ITEM #: 55  
DATE: 4-14-15

**COUNCIL ACTION FORM**

**REQUEST: PRELIMINARY PLAT FOR QUARRY ESTATES CONSERVATION SUBDIVISION**

# Attachment C: Lot Layout

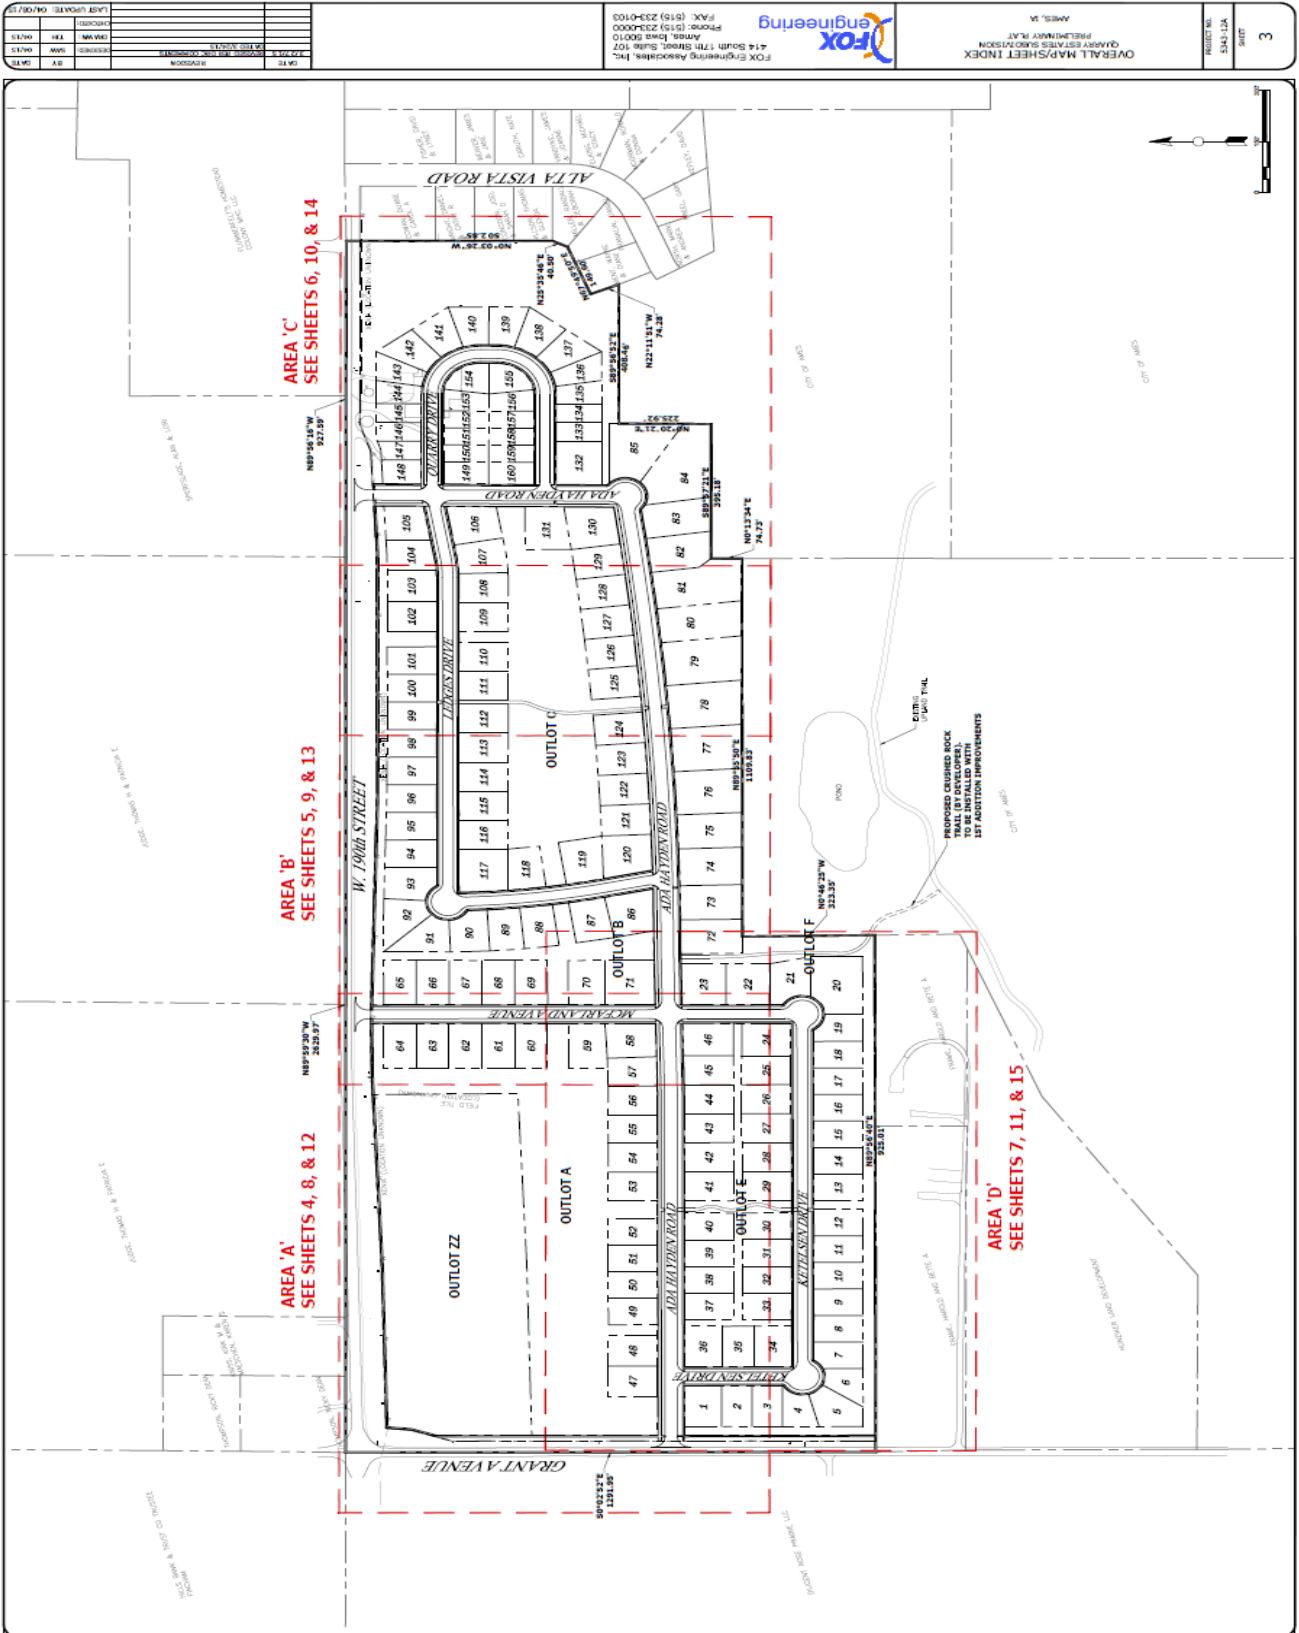
Preliminary Plat includes 14 large lots for single-family detached homes along the south side of Ada Hayden Road adjacent to the park. There are three additional lots off of McFarland Drive adjacent to the park. There are approximately five lots along the south side of Quarry Drive adjacent to the park as well. Varying sized conservation easements are proposed between these homes and the park. At the time of Planning and Zoning Commission review, all of the conservation areas were shown as outlots as requested by staff of the applicant. The outlot south of Ada Hayden Drive varied in width from 30 to 50 feet. Staff reported to the Commission that it was still working on the details with the developer, such as the location of the rear building setback line and how the rear boundary of the 14 lots would be delineated with the conservation easement.

**The applicant now proposes a Preliminary Plat for City Council approval that contains some revisions to this buffer.** It is now proposed to be a conservation easement within each of the private lots for the 14 lots south of Ada Hayden Drive. The other areas remain as outlots. The proposed conservation area would vary in width from 30 feet to 85 feet. The applicant proposes this arrangement to address concerns about rear setbacks and developable areas of lots. As an easement rather than an outlot, there will be additional developable area on each lot that is not impacted by the rear setback from the property line. This is because the minimum setback of 20 feet falls within the conservation easement whereas with an outlot it would be from the closer property line to the homes than from the park boundary.

The applicant has also supplied additional details for delineation of the easement to help avoid the encroachment issues that are of concern to staff. The conservation easement will include the planting of tall prairie grasses coordinated with park plantings, a variety of large boulders along the conservation easement line, the installation of capped short wood posts with native prairie planting information along with each lot, and the creation of a limestone chip or gravel band that is 2-3 feet wide for the width of each lot that may also include a slight grade change or crease as well.

1. The City Council can approve the Preliminary Plat for Quarry Estates at 904 W. 190<sup>th</sup> Street with the following conditions
  - A. Provide a north bound turn lane and also a south bound turn lane with minimum storage of 150 linear feet where Ada Hayden Road intersects Grant Avenue. Developer will be eligible for reimbursement of 50% of the initial construction cost of the turn lanes from the development west of the site as collected from the “Rose Prairie” developer. Alternatively, the developer shall be responsible for reimbursement of 50% of the cost of construction if the development to the west is built prior to the connection of Ada Hayden Road.

- B. Prior to final plat, include in the street lighting plan a light at each intersection of Ada Hayden Road and McFarland Avenue with 190<sup>th</sup> Street and continue the regular spacing between lights from there into the subdivision.

- C. To ensure appropriate space is reserved for street trees and off-street parking coordinated with driveway placement, before approval of the final plat that includes Quarry Drive, provide to the Planning and Housing Department a plan with the placement of street lights, street trees, and hydrants, and driveways for Quarry Drive.
